Via Electronic Transmission Only

February 8, 2013

Re: ENERGY STAR Version 6.0, Draft 2 Report (“Draft 2”)

Figure 1: Years Required to Recover Costs of Window Replacement in Northern Climate Zone in Whole House¹

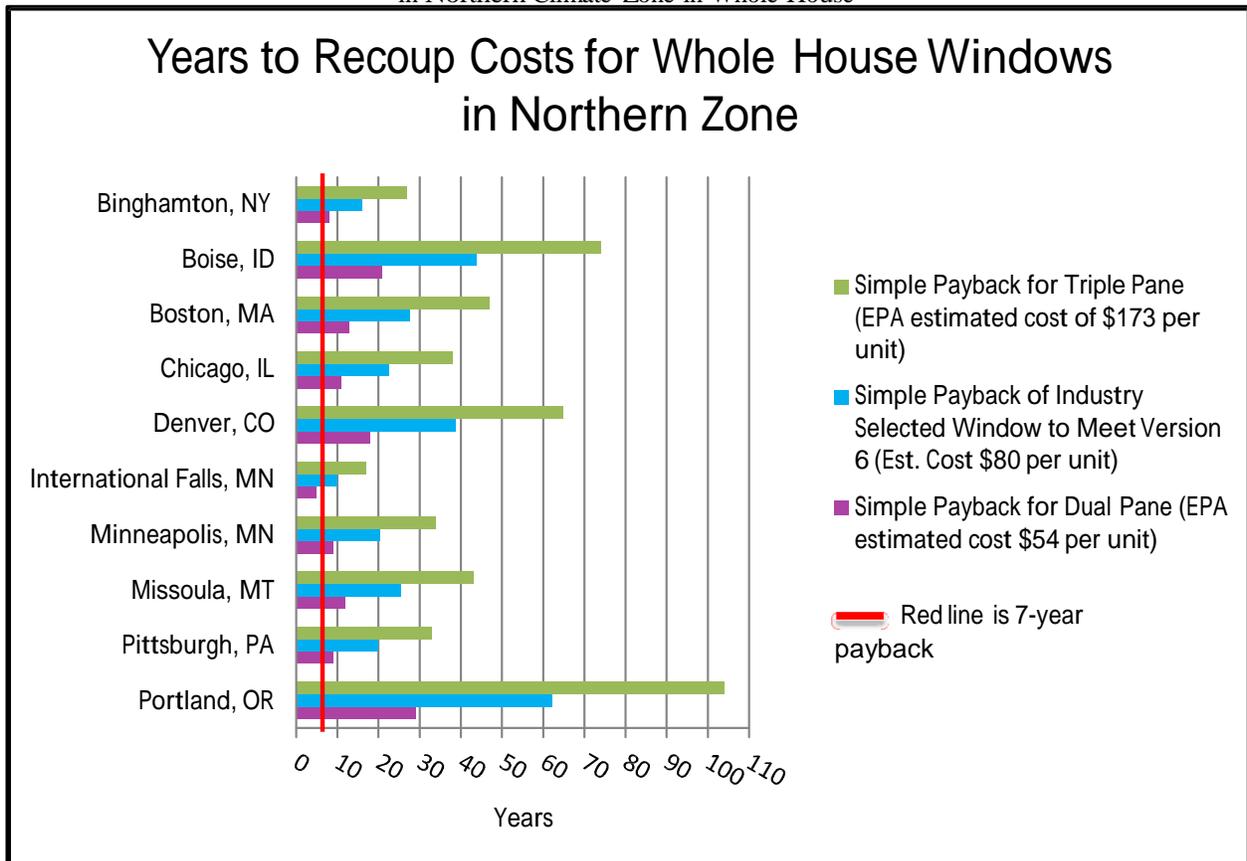
Figure 1 below, illustrates the payback years to recover the cost of replacing windows in the Northern climate zone. The average payback period for an industry selected window to meet Version 6 criteria in the Northern climate zone is 29 years. For example in Boston, which is a heating dominated climate, the payback period is 13 years for dual pane based on EPA estimated costs, 28 years to meet Version 6 based on industry estimate, and 47 years for triple pane based on EPA estimated costs. These paybacks do not represent a reasonable, consumer-acceptable time period, nor do they meet the ENERGY STAR Guiding Principles.

Therefore we propose the following changes in U-Factor and SHGC criteria for each of the climate zones to help consumers realize energy savings with reasonable payback periods.
